Access Compliance Report

Public Rights-of-Way

| Intersection ID: N/A | Main Street: WINGATE_AV | Cross Street: MAYFAIR_AV | Location: SE |
| ADA ID: 69D070096F2A | Ramp Type: Perp | Initial Pass/Fail: Fail | Overall Compliance: No |

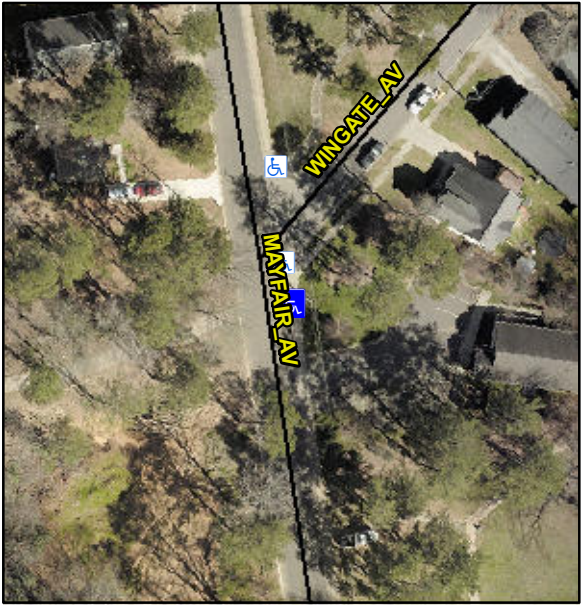
| | Remove & Replace Entire Ramp. | N/A | Ramp Length (in) | 71.5 | No | Ramp Slope (%) | 8.4 |
| | | Yes | Ramp Width (in) | 48.0 | No | Ramp XSlope (%) | 3.8 |
| <p>Surveyor Notes:</p> <p>N/A</p> <p>PROW/ADA:</p> <p>Not Found, R304.2.2, R304.5.3</p> | | | Road Slope (%) | N/A | N/A | Clear Space? | N/A |

|  | Possible Solutions: | Compliance | Description | Data | Compliance | Description | Data |
